Enclosure 3  
February 2009 Meeting Handouts  
Meeting Summary of the 02/11/09 Reactor Oversight  
Process Working Group Public Meeting  
**Dated March 11, 2009**

*ROP Task Force Comments Following the NRC Working Meeting with Stakeholders to Discuss an NRC Proposal for Integrating Traditional Enforcement in the Reactor Assessment Program*

## Proposed Change to Risk Cap

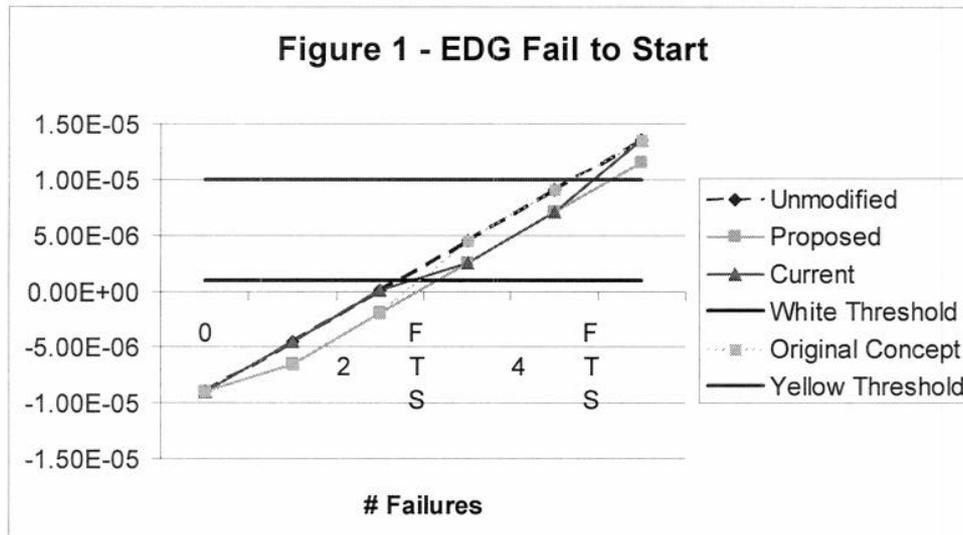
Figure 1 shows the impact of each additional EDG failure to start. It should be noted that both the current and proposed risk cap treatment results in the same MSPI color regardless of the number of failures.

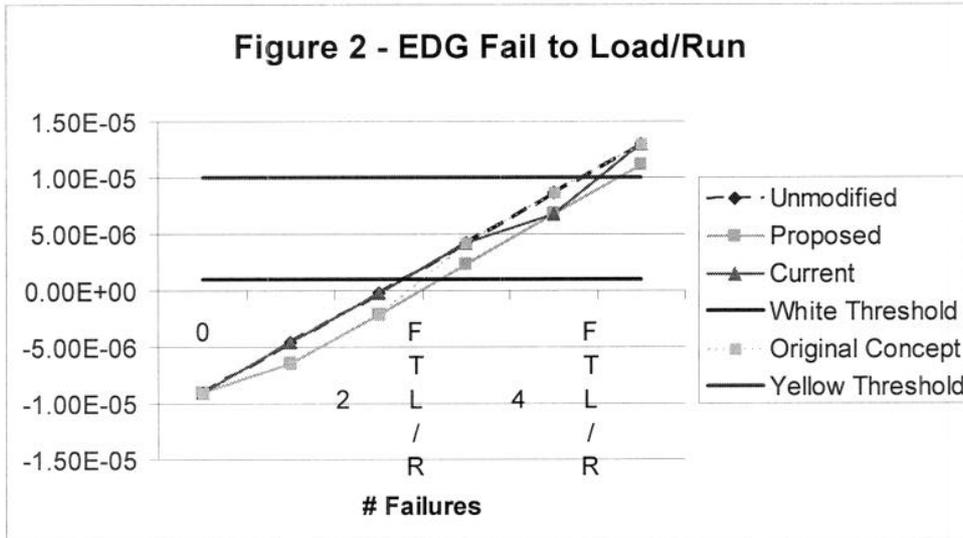
Figure2 shows the impact of each additional EDG failure to load/run. As with failures to start, both the current and proposed risk cap treatment results in the same MSPI color regardless of the number of failures.

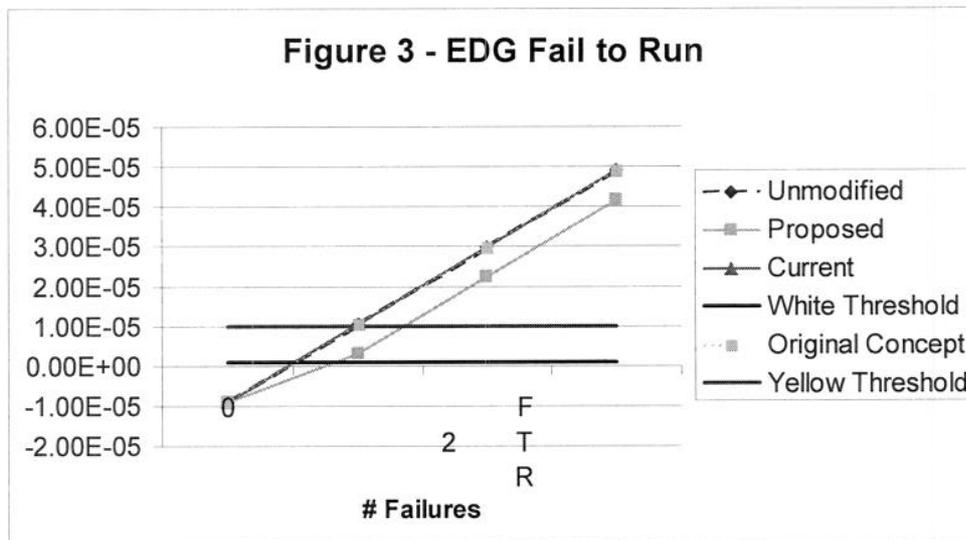
Figure3 shows the impact of each additional EDG failure to run. The primary difference between the current Risk Cap and the proposed Risk Cap is that under the current risk cap, a single failure (with the included contribution from unavailability) results in a Yellow MSPI, while under the proposed change to the Risk Cap, this results in a White Configuration. A second failure results in a Yellow MSPI from both approaches.

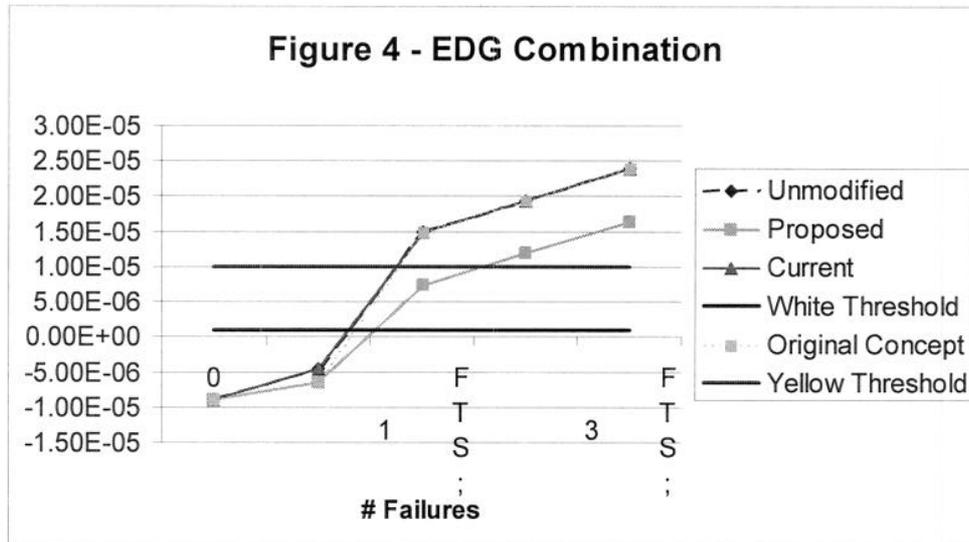
Figure 4 shows the impact of from different failure modes. The first failure is assumed to be a failure to start, followed by a failure to run then additional failures to start. Under the current Risk Cap treatment, the MSPI jumps from Green to Yellow following the failure to run, even though neither failure may be statistically significant. The proposed Risk Cap change results in a smoother transition (Green, White, Yellow) as additional failures are added.

### Example 2: NUREG-1816, Case 1

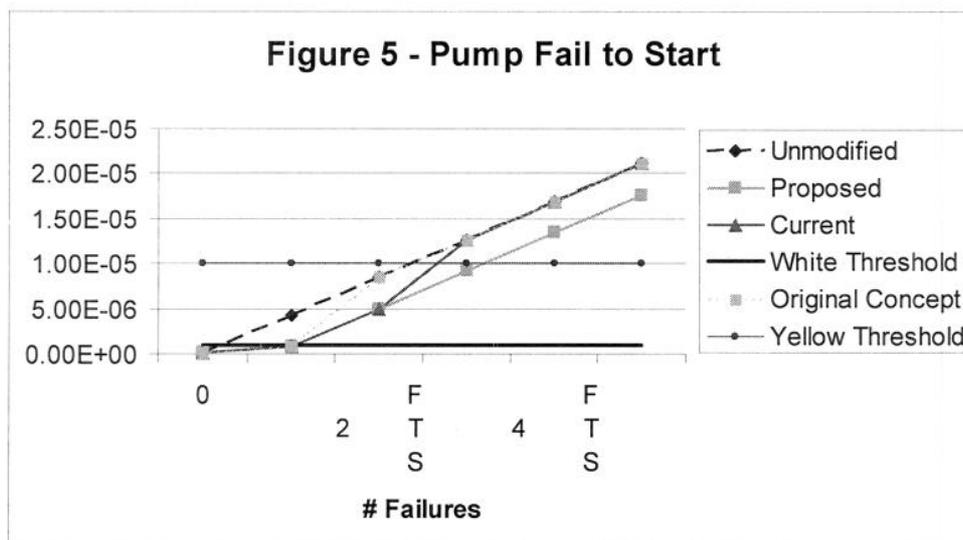
For this example, a plant experiences a start failure of an Auxiliary Feedwater motor-driven pump. Prior to the failure, the  $UAI = 1 \times 10^{-7}$ . The delta URI associated with the start failure is  $4 \times 10^{-6}$ . No other failures have occurred during this reporting period yielding an URI baseline of zero (this is a simplification since baseline could be below zero). The UAI contribution resulting from the repair unavailability is  $2 \times 10^{-7}$ . For this scenario, both the current Risk Cap and proposed change result in exceeding the White Threshold after the 2<sup>nd</sup> failure. However, it does require 1 additional failure (4 failures versus 3 failures) to exceed the Yellow threshold under the proposed change to the Cap (See Figure 5).

### Example 3 – Essential Service Water Pump Failure to Run

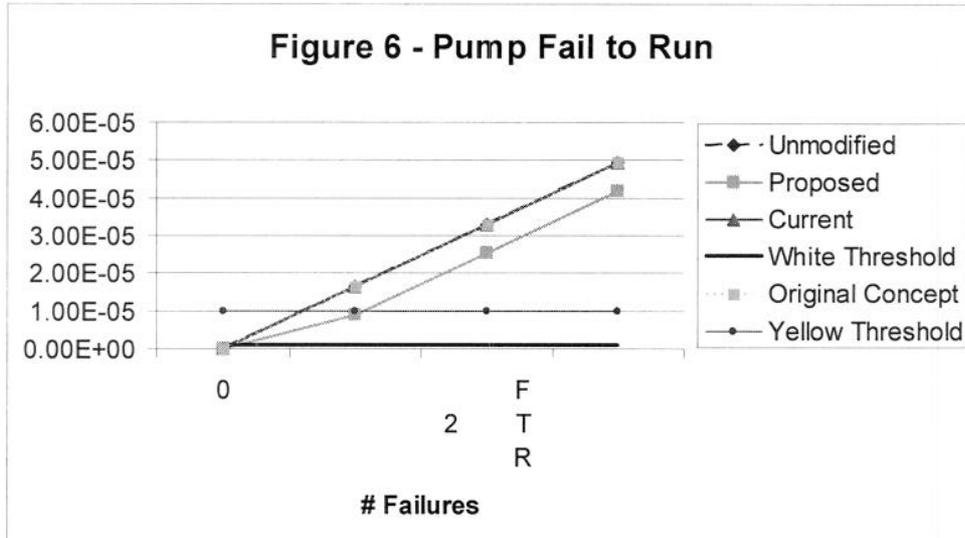
For this plant, a single failure to run results in a Yellow MSPI under the current Risk Cap. With the proposed Risk Cap, the MSPI is White following a single Failure to Run and Yellow after the second failure (See Figure 6).

### Example 4 – Increasing UA

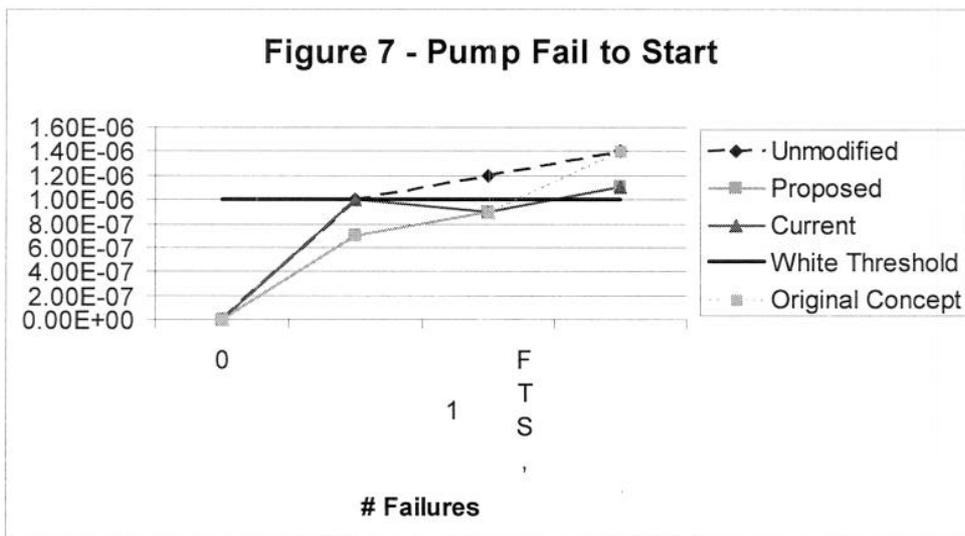
For this example, it is assumed that the MSPI is at 0 and that a Failure to Start has a URI contribution of  $8E-7$ . Following the first failure, the UA contribution is increase in  $2E-7$  increments. As can be seen in Figure 7, since the current Risk Cap is only applied once the MSPI exceeds  $1E-6$ , increases in UAI can result in a decrease to the MSPI value. The revised Risk Cap eliminates this discrepancy.

## Review of EDG Fuel Oil Transfer Pump

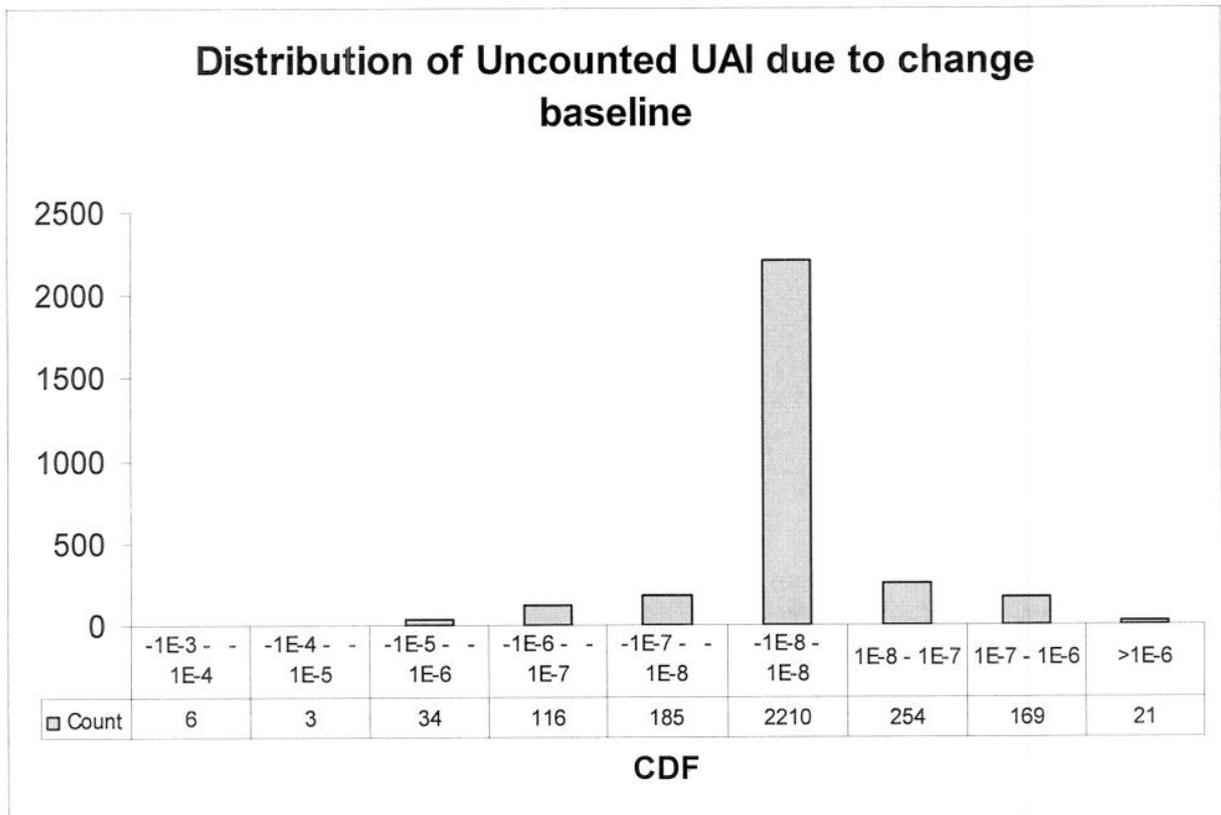
Given the differences in Day Tank capacity, the number of transfer pumps per EDG, as well as the number of EDGs available at a unit, makes the risk worth (Birnbaum) of the FO Transfer pumps vary widely from plant to plant. The range of Birnbaum values for the FO Transfer Pumps is shown below:

Given the variation in the importance of EDG Fuel Oil Transfer Pumps, with the potential for the pumps to have a significant risk contribution, the following recommendations are made:

1. The current scoping/boundary definition for the EDGs should remain unchanged.
2. The fuel oil transfer pumps should be added as separate monitored components to the EDG system.
3. The  $1E-6$  Birnbaum exclusion for breakers and valves should be applied to the FO Transfer Pumps

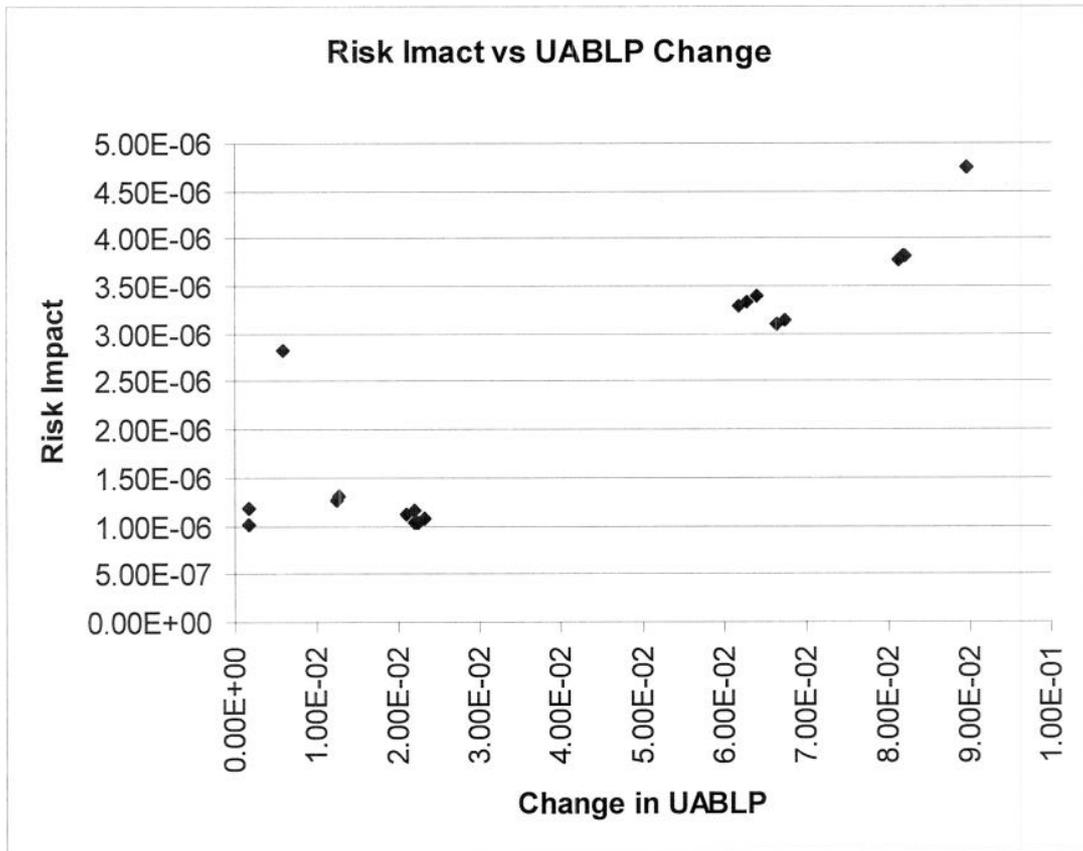
The chart below is a plot of the risk impact of the change to the planned unavailability baseline which is not being counted as compared to the actual planned unavailability baseline change for those changes which resulted in a risk impact greater than  $1E-6$ . Some points to note:

1. All of these changes were to the cooling water system
2. 17 or 21 changes were from the same plant. Given the large amount of unplanned unavailability not being considered by this plant, additional information should be obtained to determine why this plant needs such a large amount of unavailability for some very high-risk significant trains.
3. Consideration should be given to capping the amount of planned unavailability that can be credited in MSPI.
